SUBSURFACE INVESTIGATION REPORT

265 CENTRUM BOULEVARD, OTTAWA, ON, K2S 1V4

Report number: 54-BOI-R2¹

16 Responses to Requests from the City of Ottawa

Figure 2: Test hole Locations Plan

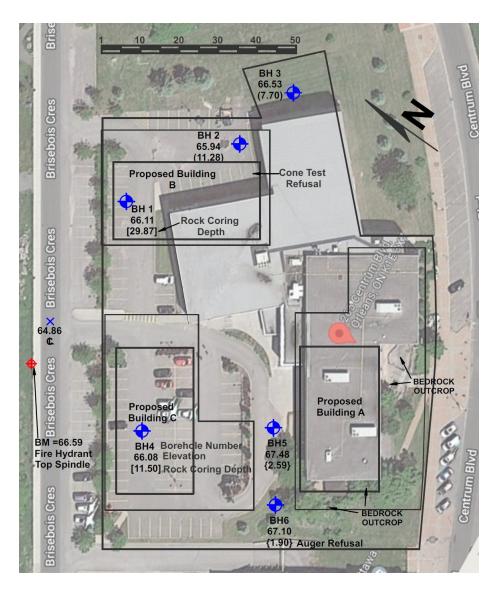
- D1. Please clearly specify the spacing between boreholes. Include discussion in the report and refer to Table 1 in the City of Ottawa Geotechnical Guidelines for the maximum allowable spacing between boreholes and test pits. Note that the Geotechnical Guidelines must be upheld and further boreholes would be required should required spacing not be met.

16.1 Response to D1 "Spacing of Boreholes"

Figure 2 in page 23 reproduces fig. 1 in page 9 with an added scale bar. It can be seen that the spacing meets the guideline of up to 50 m spacing between holes.
